# GWA - ADA Evaluation

**LE- Hamilton TX, TGWTC ADA Evaluation**

**4363 FM1047**

**Accessibility Evaluation**

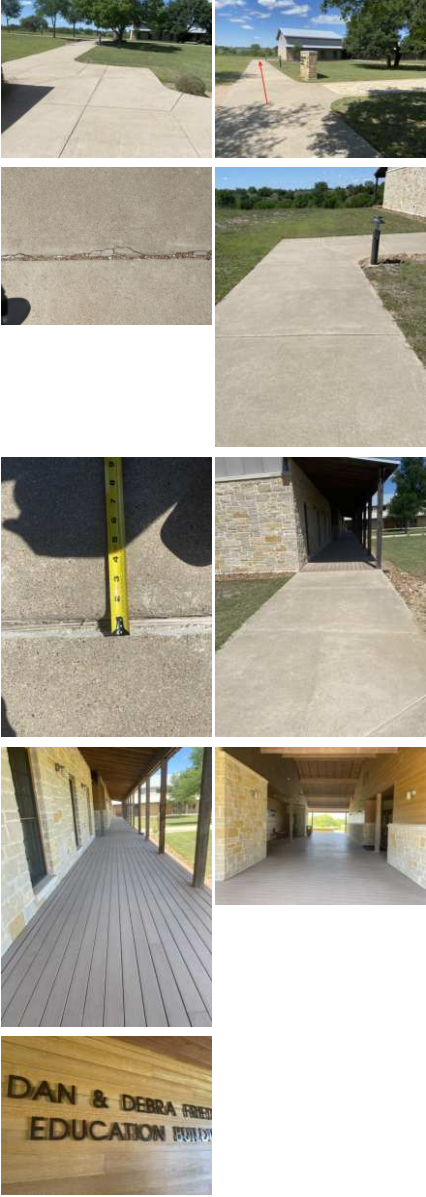
Finding Number	Area Description	Finding	As Built	Recommendation	Citation	Photos	Figure
5	Exterior of Property (Public Tour) : Parking Lot- 2 Van 2 Car spots (Cafeteria) - Path of Travel to Cafeteria from Parking Lot	The striping for the accessible parking stalls loading/unloading access aisle is missing. Access aisles shall be marked so as to discourage parking in them.	Side walk leading to cafeteria has access aisle area with no parking markings missing. Cafeteria parking lot side walks leads to leadership quarters, there is no direct path to main cafeteria entrance.	<a href="https://www.access-board.gov/ada/#ada-502_3_3">https://www.access-board.gov/ada/#ada-502_3_3</a>	2012 TAS Section: 502.3.3  2010 ADAS Section: 502.3.3		
6	Exterior of Property (Public Tour) : Parking Lot- 2 Van 2 Car spots (Cafeteria) - Path of Travel to Cafeteria from Parking Lot	The route contains openings greater than 1/2 inch. Openings in floor or ground surfaces shall not allow passage of a sphere more than 1/2 inch diameter. Elongated openings shall be placed so that the long dimension is perpendicular to the dominant direction of travel.	There are several locations where exterior pathway gap exceeds 1/2" tolerance. This section of pathway leads from cafeteria parking lot to cafeteria main entrance. See additional photos for location of gap non compliance on accessible pathway to building.	<a href="https://www.access-board.gov/ada/#ada-302_3">https://www.access-board.gov/ada/#ada-302_3</a>	2012 TAS Section: 302.3  2010 ADAS Section: 302.3

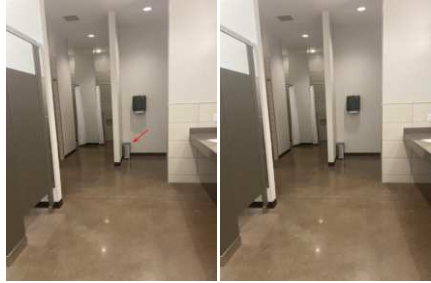
25	First Floor Building Interior (Public Tour) : Cafeteria Meeting Area (Tour) - Restroom (Men's)	The rear grab bar does not extend adequately past the toilet on the wide side. The rear grab bar must be a minimum of 36 inches long and extend from the centerline of the toilet 12 inches minimum on wall side and 24 inches minimum on the wide side. Grab bars shall be installed in a horizontal position, 33 inches minimum and 36 inches maximum above the finish floor measured to the top of the gripping surface and the space between the grab bar and the top of the tank shall be 1-1/2 inches minimum.	Rear grab bar does not extend required length in either direction due to wall barrier. Rear grab bar can be 24" due to exemption but needs to be centered over toilet. Wall does not allow rear grab bar installation to be centered on toilet.	N/A - Refer to Finding	2012 TAS Section: 604.5.2  2010 ADAS Section: 604.5.2

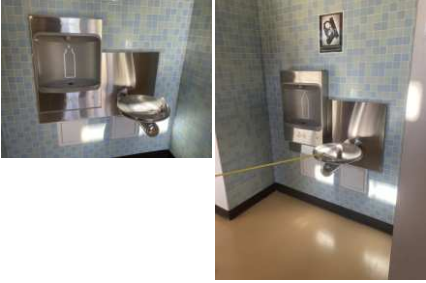
48	First Floor Auxiliary Classroom (STAFF): Interior Hallways of Building - Kitchenette	There is a change in level that exceeds the allowable range. A 1/4 inch is the maximum vertical rise. Changes in level between 1/4 inch and 1/2 inch must be beveled at 1:2 or less. Changes in level greater than 1/2 inch must be by way of a ramp.	Interior pathway leading to restroom has change in elevation/lip exceeding 1/4"	<a href="https://www.access-board.gov/ada/#ada-303_2">https://www.access-board.gov/ada/#ada-303_2</a>	2012 TAS Section: 303.3 2010 ADAS Section: 303.3
